Access Compliance Report Public Rights-of-Way (Curb Ramps)

Intersection ID: 49817 Main Street: ASHLEY_VIEW_DR Cross Street: SIDNEY_CREST_AV Location: W

ADA ID: BA2A0276D522 Ramp Type: PerpDiag Initial Pass/Fail: Fail Overall Compliance: No Severity Score: 8.75

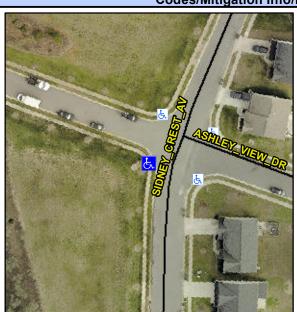
Not Found, R304.5.1

Remove & Replace Curb Ramp With Two New Directional Ramps or Equivalent.
